Subject: USNRC Docket No. 72-1014, TAC L23344
HI-STORM 100 Certificate of Compliance 1014
HI-STORM License Amendment Request 1014-1, Revision 2, Supplement 1

U. S. Nuclear Regulatory Commission
ATTN: Document Control Desk
Document ID: 5014433

INSTRUCTIONS FOR LAR 1014-1, REV. 2, SUPPLEMENT 1

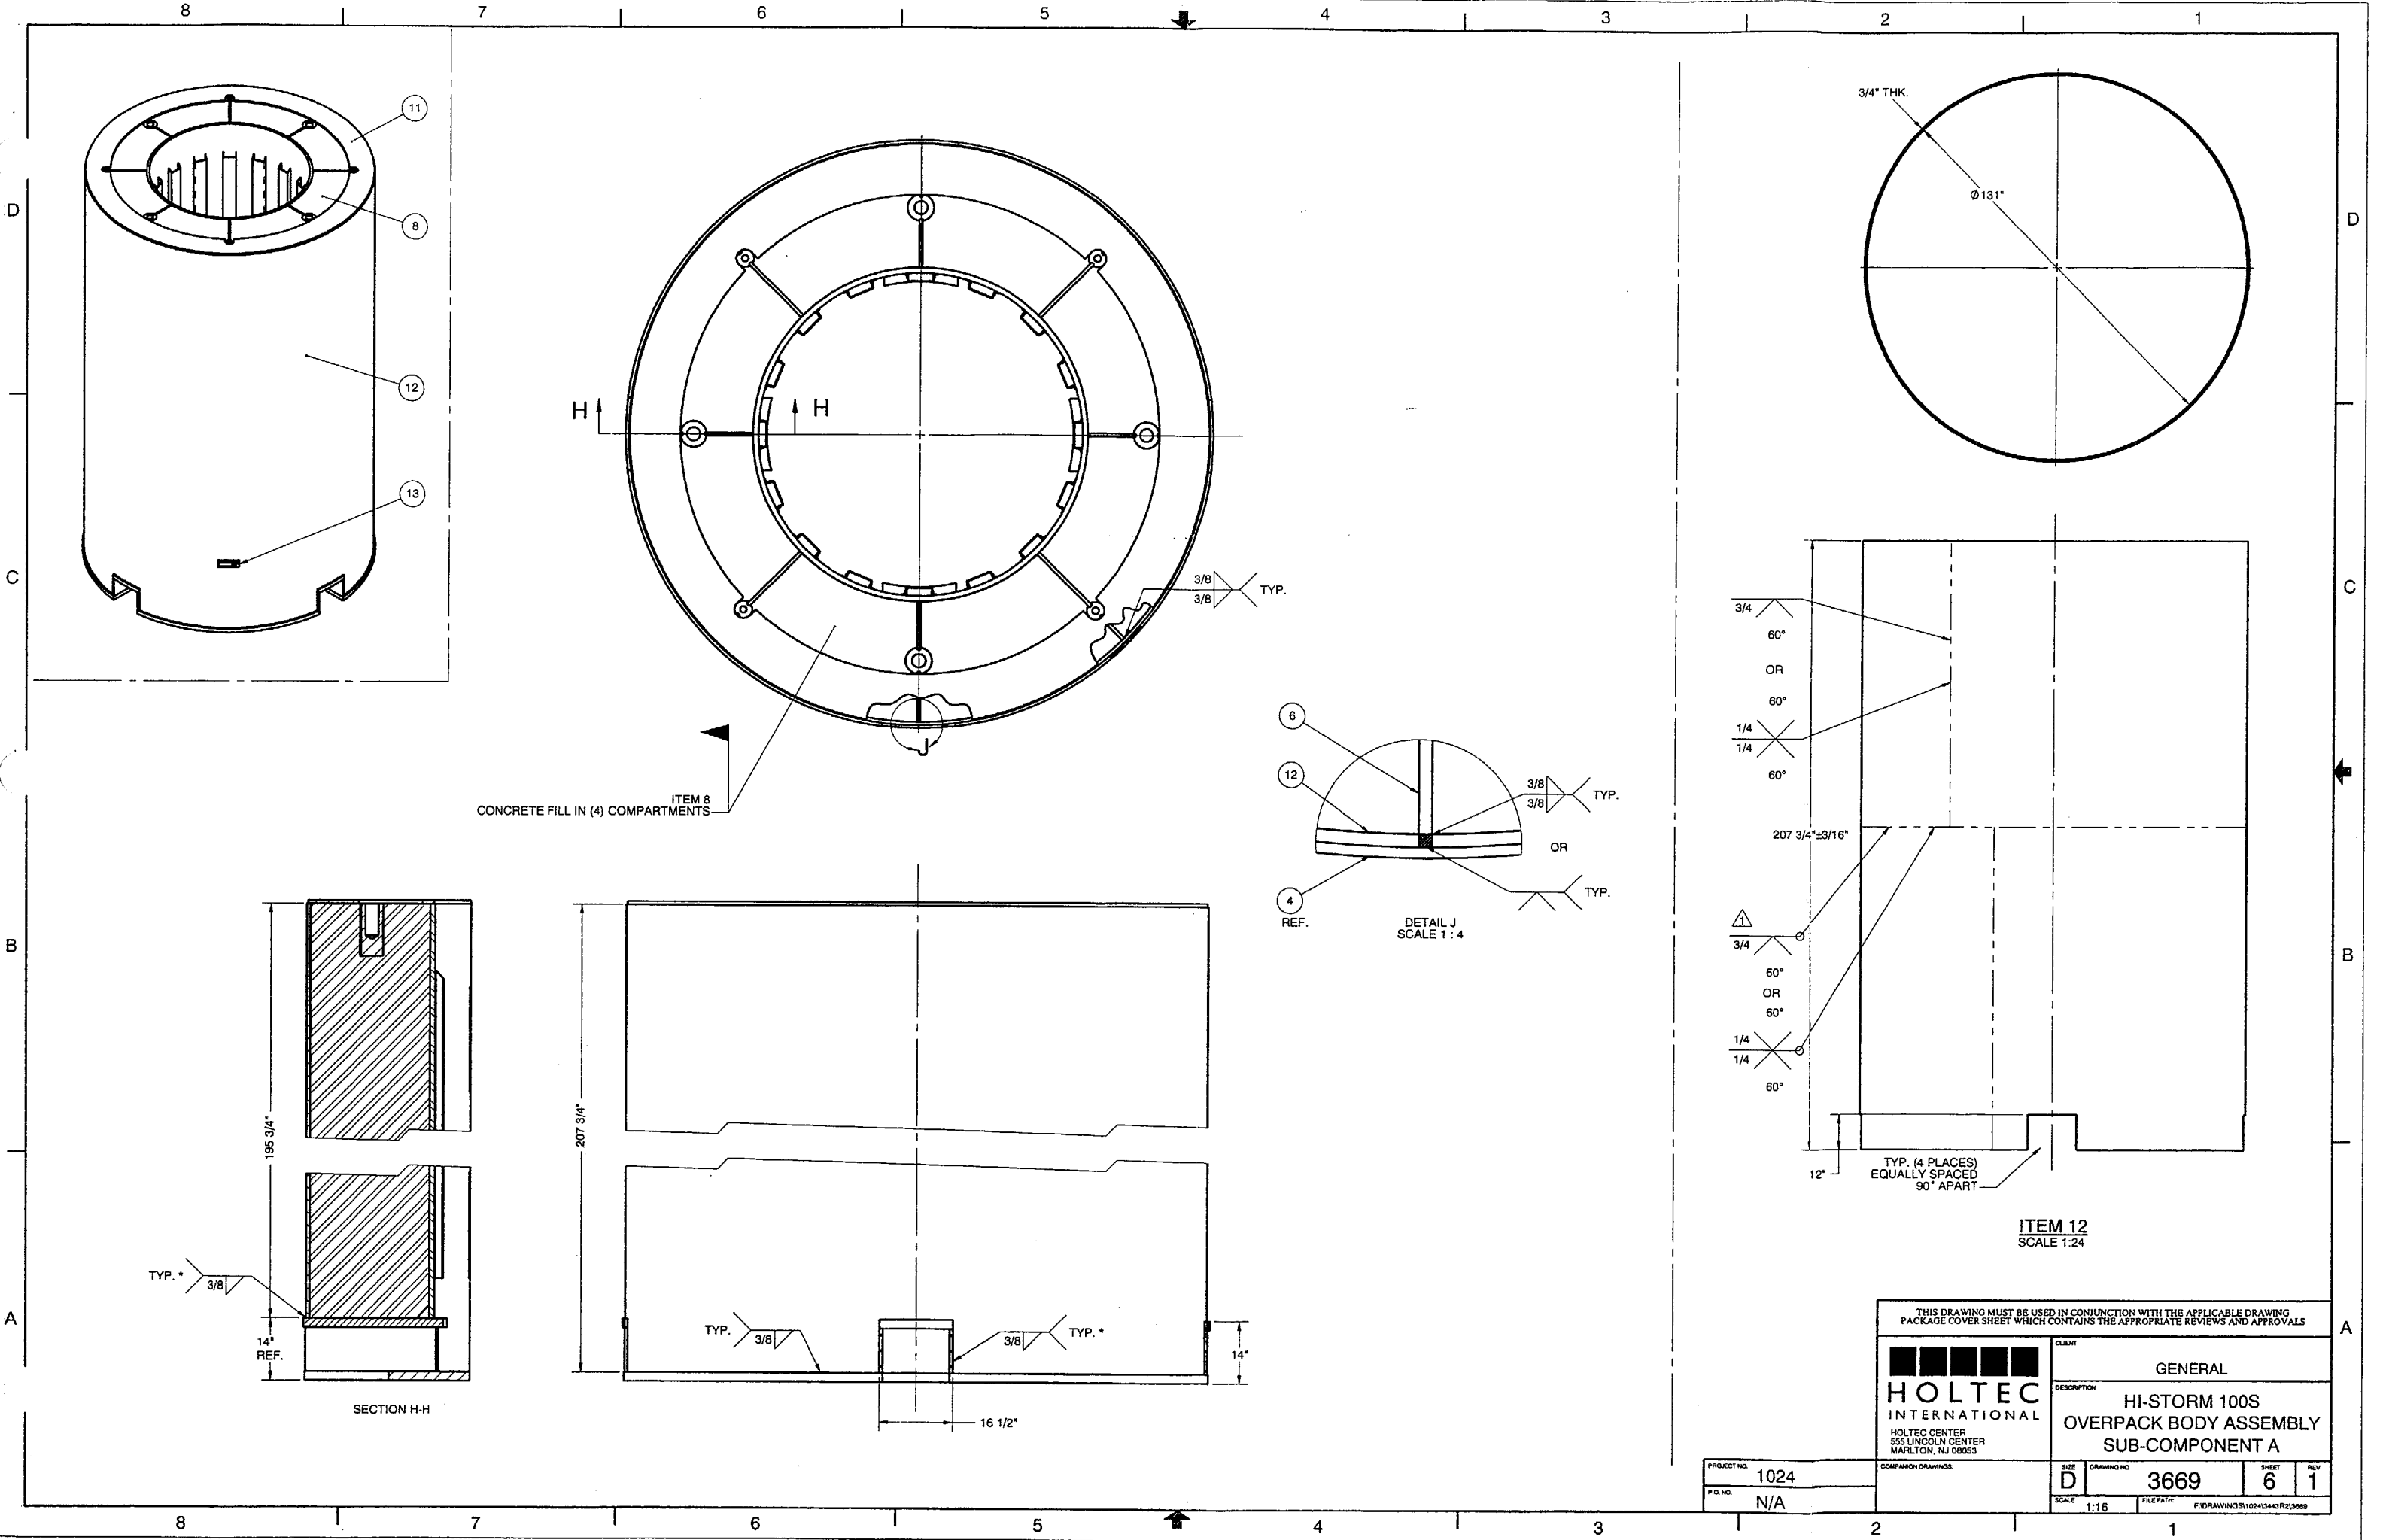
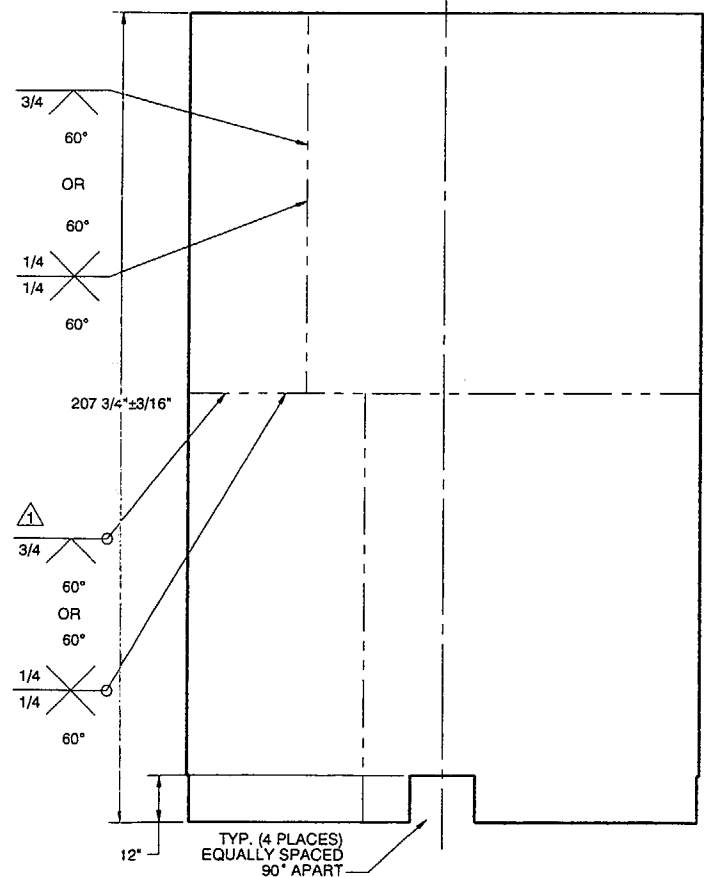
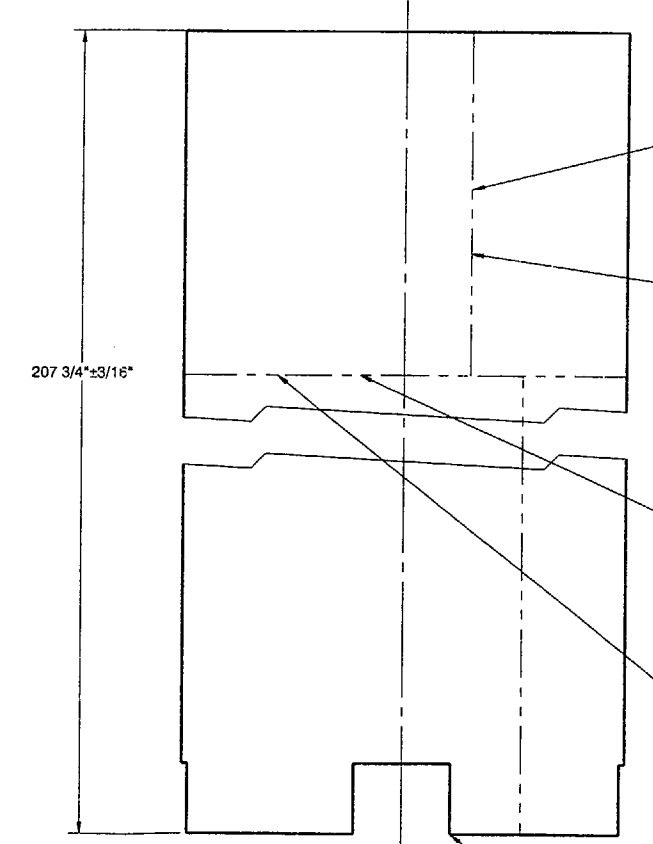
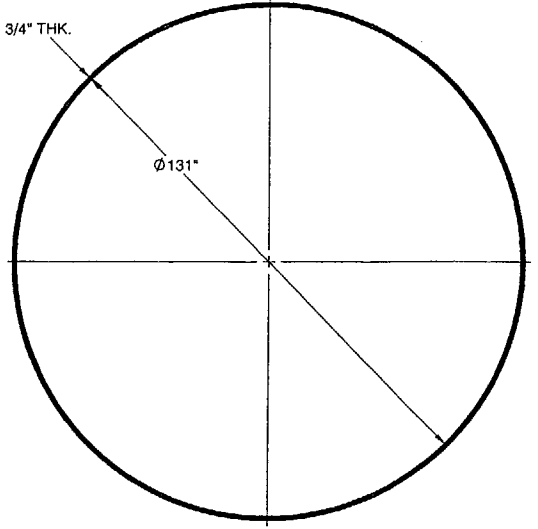
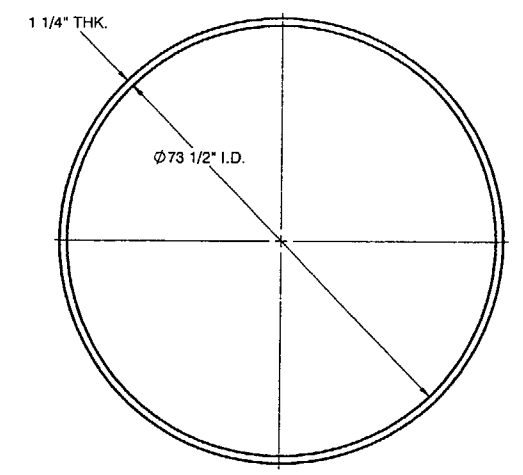
ITEM	DESCRIPTION	REASON FOR CHANGE	AFFECTED LAR DOCUMENT
1	<p>a. The weld call-out in the detail for BOM Item 2 on Sheet 5 of Drawing 3669 was corrected to point at the horizontal weld rather than the vertical weld.</p> <p>b. The size of the horizontal weld on BOM Item 12 shown on Sheet 6 of Drawing 3669 was increased from 3/8" to 3/4".</p>	Drafting errors.	Drawing 3669, Sheets 1, 5, and 6
2	The dose rates reported FSAR Chapter 5, for HI-STORM 100S are slightly modified.	Inconsistency in the MCNP shielding models. The concrete density in HI-STORM 100S overpack lid was inadvertently modeled as the same density as the overpack body. This has been corrected to be consistent with the densities specified in Proposed Rev. 1B of FSAR Appendix 1.D.	FSAR Chapter 5, Tables 5.1.1, 5.1.3, 5.1.4, and 5.1.6
3	Text in FSAR Chapter 5 related to changes implemented under 10 CFR 72.48 is removed.	This information is not part of the scope of the amendment request.	FSAR Chapter 5, Section 5.3.1, items 4, 5, and 6 under "HI-TRAC modeling discrepancies"

FIGURE 2.1.1; DAMAGED FUEL CONTAINER FOR
DRESDEN UNIT-1/ HUMBOLT BAY SNF

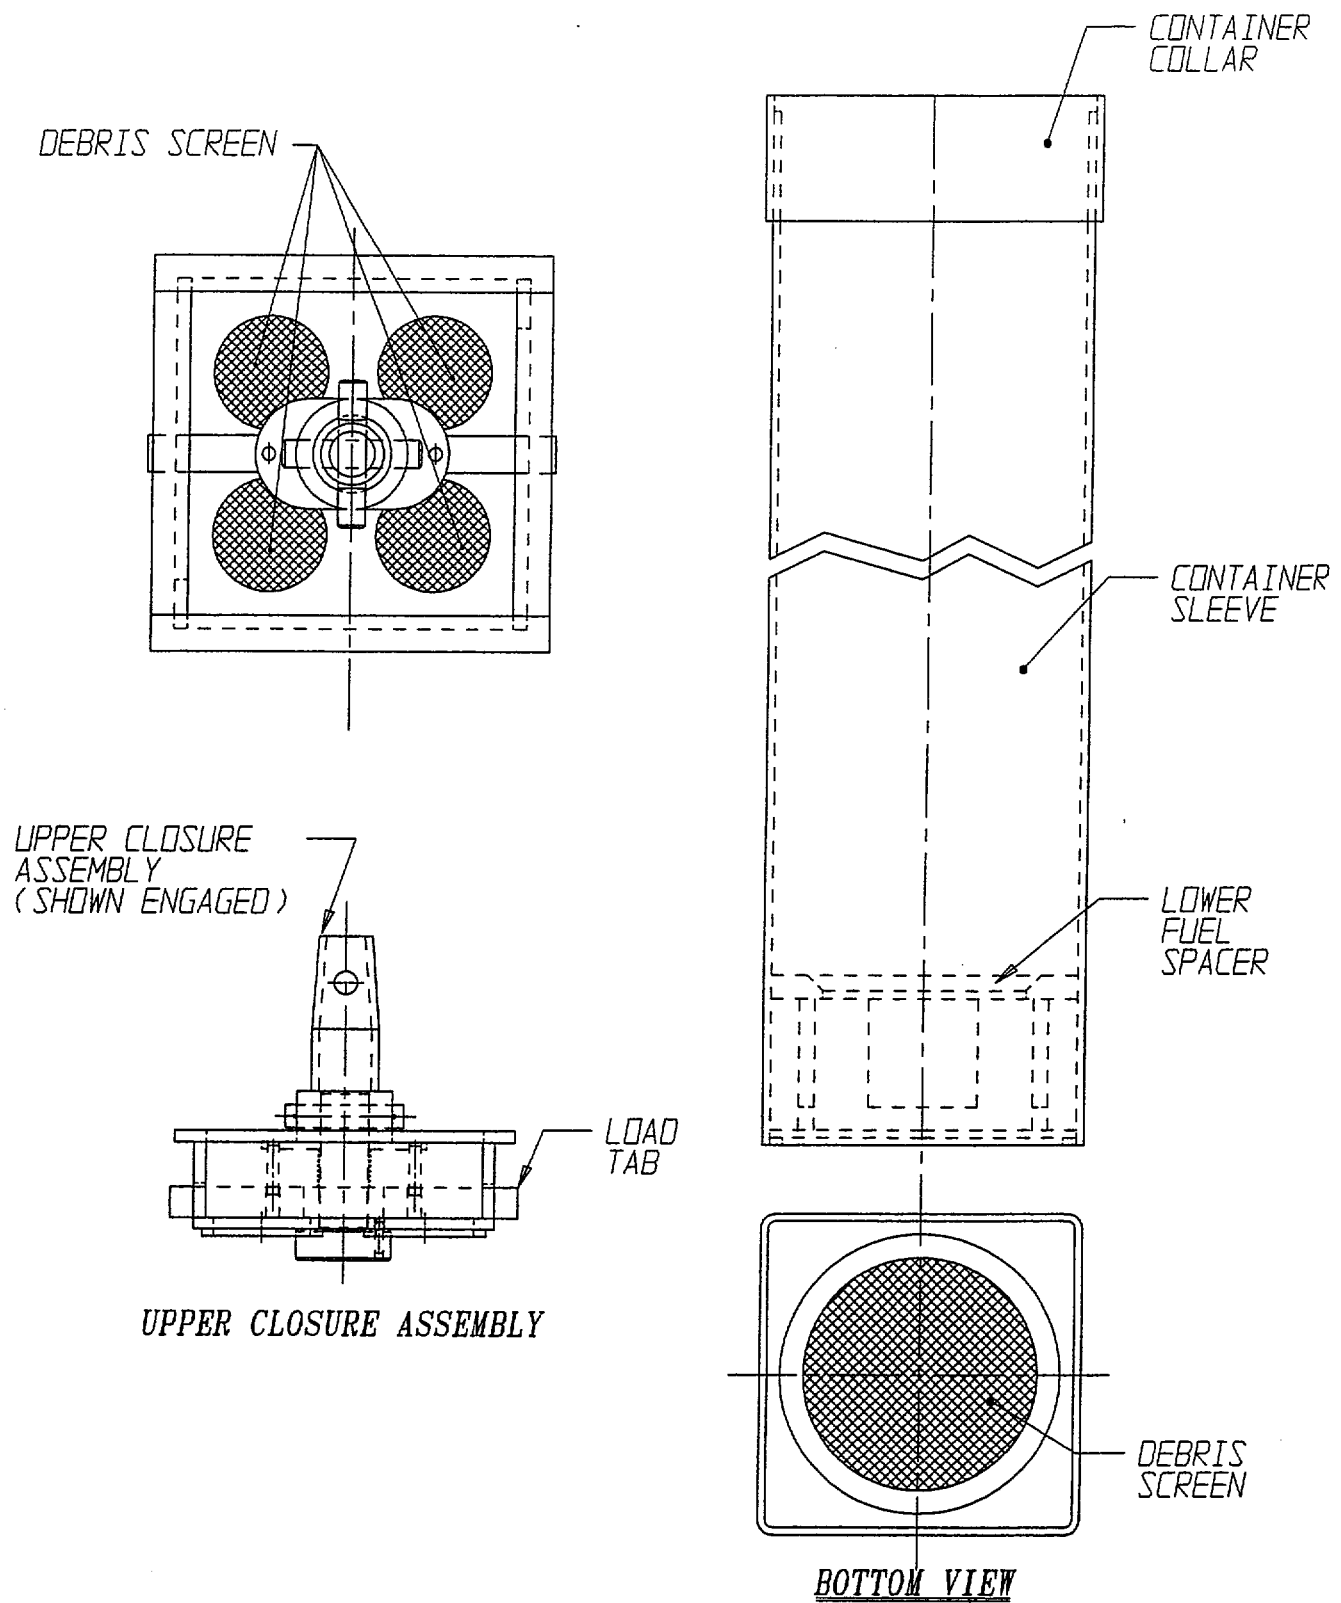
4	CoC clarification to ensure users understand the stated conditions are applicable to MPC-68F and MPC-68FF in addition to MPC-68	Clarification to avoid confusion	CoC Appendix B, Section 2.1.1.d
5	Add Figures 2.1.1, 2.1.2, and 2.1.2A through 2.1.2C to the LAR package.	Administrative oversight. These figures were in the original proposed FSAR changes for the LAR. In revision 1B, the height of the container shown on Figures 2.1.2B and C is changed to "variable" from a specific height.	FSAR Chapter 2
6	FSAR correction of the stress analysis of the MPC pedestal shield	Incorrect value used in analysis	Appendix 3.D, Section 3.D.8
7	FSAR clarification regarding analysis of vertical handling of HI-STORM 100 vs. HI-STORM 100S overpacks	Text change required to reflect separate analysis performed for HI-STORM 100S	Appendix 3.D, Section 3.D.2
8	Correction to CoC to indicate PWR capacity of system will be 32 assemblies.	Addition of MPC-32 canister increases PWR capacity	CoC Section 1.a
